Tillegra Dam – Response to DoP Questions

**Project No. 003618/01/08/06
DoP Ref: 09/00891**

Hunter Water Corporation

Figure 1a – Typical structures affecting flooding in the lower estuary.

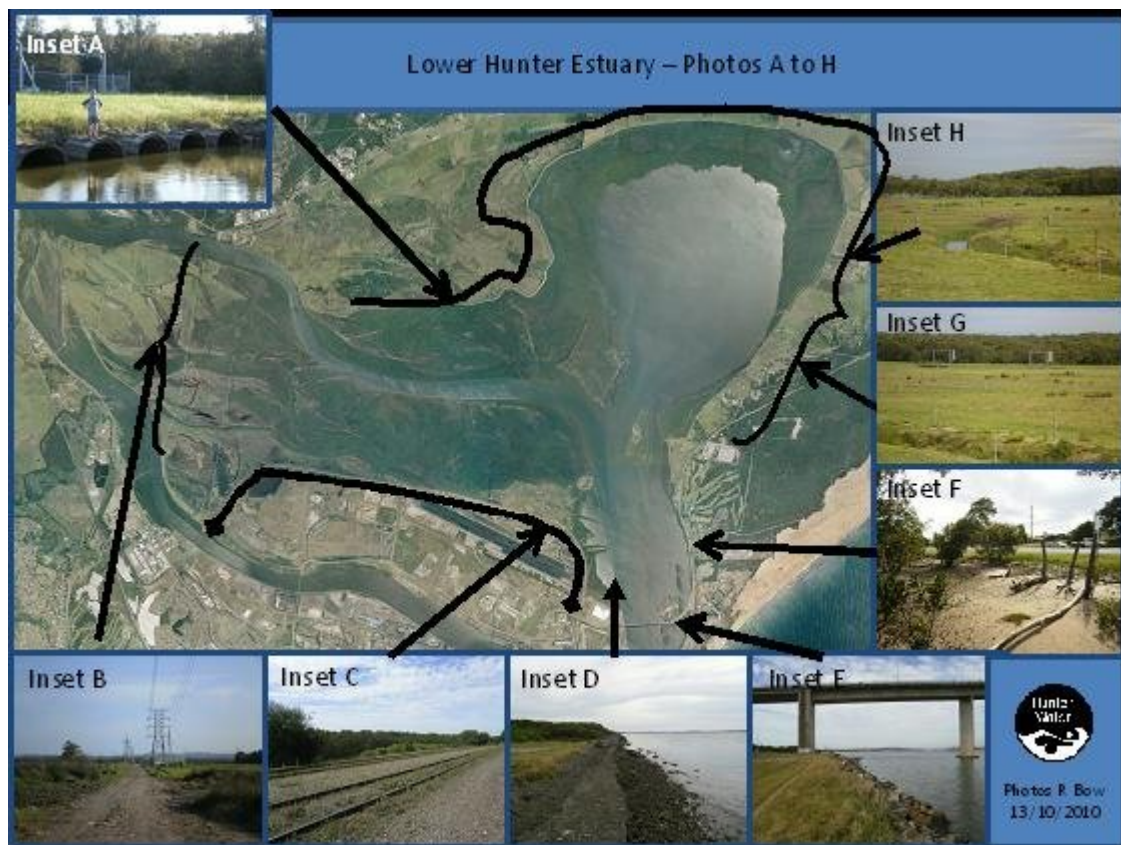
We agree with the reviewers and NSW Planning that the intuitive expectation should be that as flood depths decrease, spatial extent of flooding should contract, as flood water does not flow as far across the upward sloping elevations of any adjacent floodplain. Consequently we understand that the mapping which shows no real changes to flooding extents may have been counter intuitive to normal expectations.

It is important to appreciate however that the Hunter Estuary and its wetlands occur in a highly modified landscape that is atypical to a normal estuarine environment. Specifically, almost the entire Hunter estuary Ramsar site is surrounded by levee banks and floodgates or

other engineered structures. These impede the free flow of water and restrict the wetlands into narrow tidal margins along the main watercourse. The flooding is constrained within these restricted areas.

In practical terms this means that tidal waters are restricted by the presence of the levee banks. When a flood occurs, it cannot extend further onto the floodplain because the levee banks hold the water in the main channel, generally around the existing mean high water extent delineated by the embankment (some levee banks were extended into the main channel and backfilled). The flood simply rises or falls almost vertically, hard up against the structures, without changing spatial extents. The inset photos in figure one (a), show the types of structures that cause this effect in the North Arm of the estuary. Figure one (b) shows the significant flood levee and ring drain surrounding Fullerton Cove.

Figure 2 – Sites in the Hunter Estuary for Impact Assessment Discussion

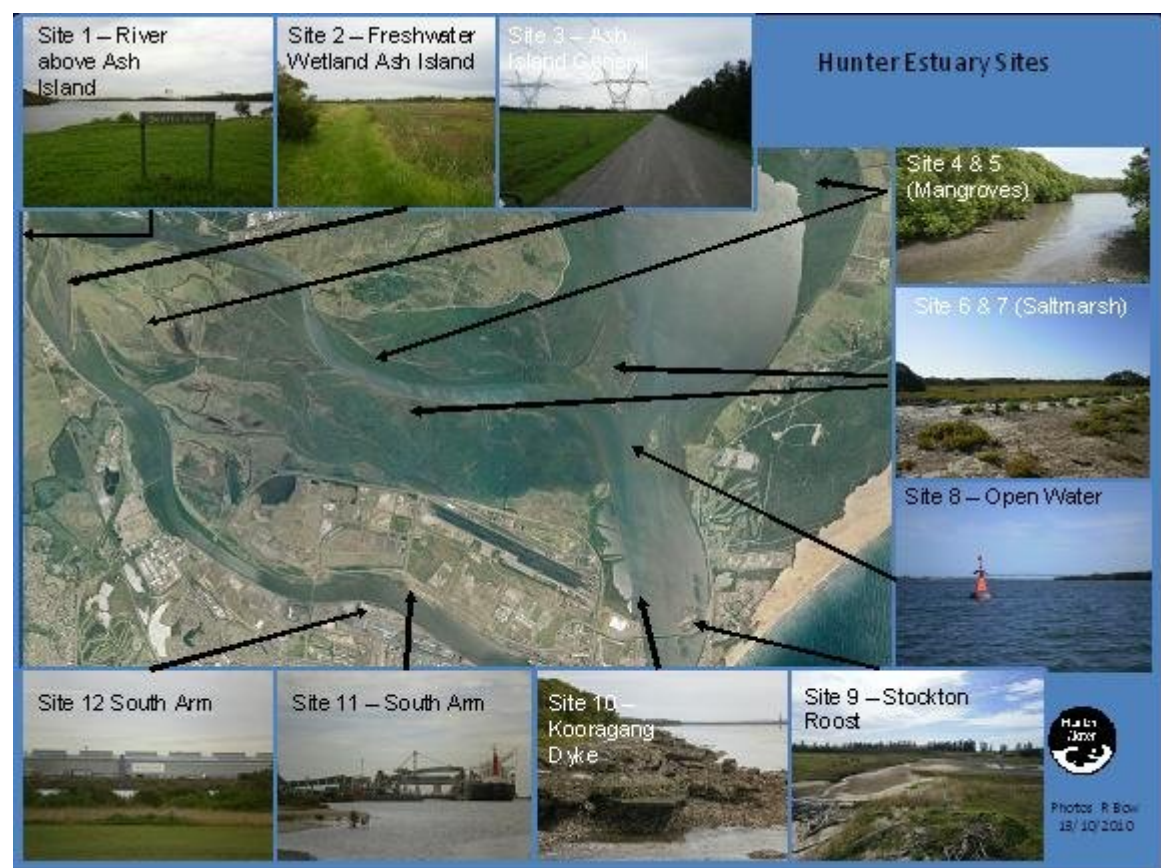
Whilst it is difficult for Hunter Water and its consultants to provide additional “mapping” as requested by NSW planning and its reviewers, we have selected several representative sites within the lower estuary to illustrate the on ground characteristics of the wetland with photographs to illustrate the character of the Ramsar wetlands and further discuss the results of the modelling at a micro level.

This should provide a more fulsome understanding of why HWC’s consultants have concluded that should Tillegra Dam be approved, there would be nil meaningful changes to the systems ecology.

These sites have been selected as representative of the characteristics of the lower Hunter Estuary in or adjacent to Kooragang Island, Ash Island, Fullerton Cove and in general, the Hunter estuary Ramsar wetlands site. The locations of each site are depicted in figure two.

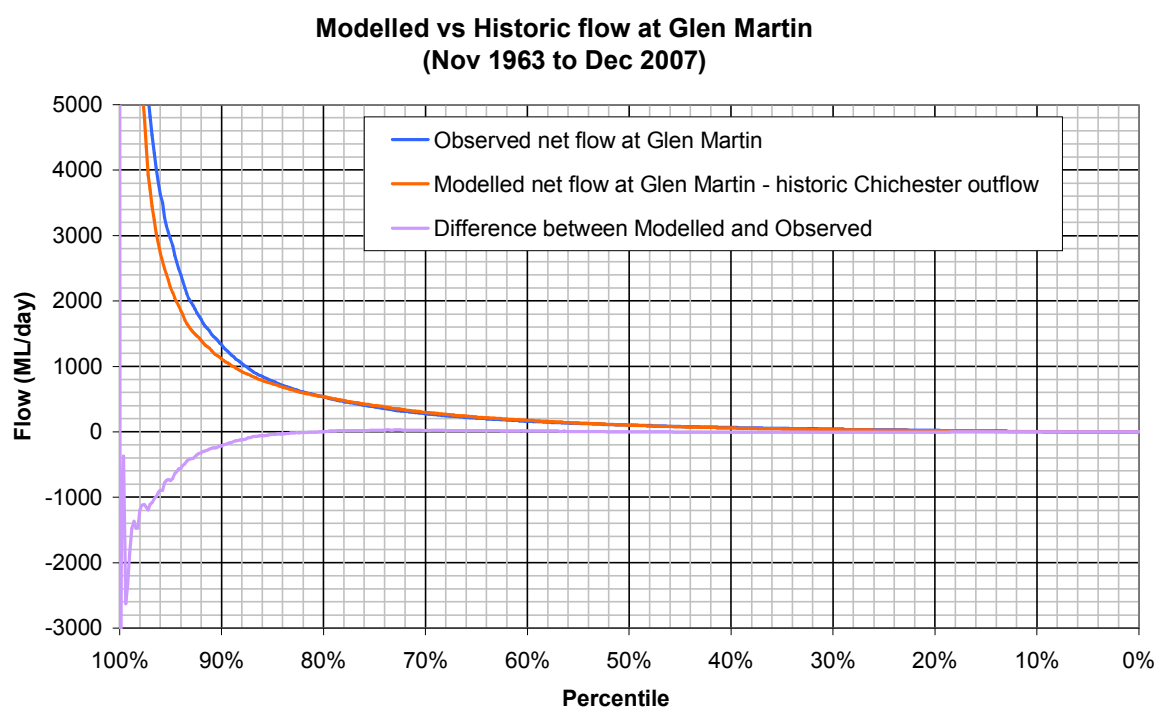
The Bewsher review has concluded that the Glen Martin residual inflows (from the ungauged catchments upstream of Glen Martin and Seaham Weir have reduced the validity, accuracy, and precision of the modelling because they have not been properly verified against recorded streamflows. The review also concluded that a correct model (for the entire period of record) will likely change some of the conclusions drawn to date such as the relative contribution of the Williams River flows to the estuary and an increased water supply to the existing system.

The primary concern expressed in the Bewsher report is that HWC did not attempt to match the average annual streamflow at Glen Martin. This is true. HWC's aim in developing the dataset was to characterise those aspects of streamflow that are important when calculating system yield and other impacts pre and post Tillegra Dam. The model calibration process that HWC adopted included simultaneous optimisation of model performance against daily and monthly flow volumes, but not annual, with HWC being satisfied that monthly calibration would be sufficient to preserve volumetric mass balance. HWC believes that differences between its approach and Bewsher's recommended approach are not material in terms of the assessment of system yield pre and post Tillegra Dam and similarly will have little (or zero) impact on the assessment of environmental and social impacts associated with the proposed Tillegra Dam.

The issue of verification of streamflow in the Williams River is a moot point. HWC supplied evidence in the report titled *Précis of Tillegra Dam EAR Hydrological Modelling* in the form of numerous modelled vs observed streamflow plots to verify that modelled streamflow is a close representation of observed streamflow. These plots include both flow duration curve comparisons as well as time series comparisons.

Our analysis shows that the HWC model has excellent agreement when representing flows on a daily and monthly basis. On occasion, the model may under represent a high flow (flood) event and cumulatively this may differ from gauged flows at Glen Martin. This does not affect the environmental assessment work undertaken, the yield calculations or the estimate of flow changes to the estuary by any significant nature. Hunter Water strongly recommends that NSW Planning read the modelling précis provided to Bewsher Consulting in regards to the modelling accuracy and precision.
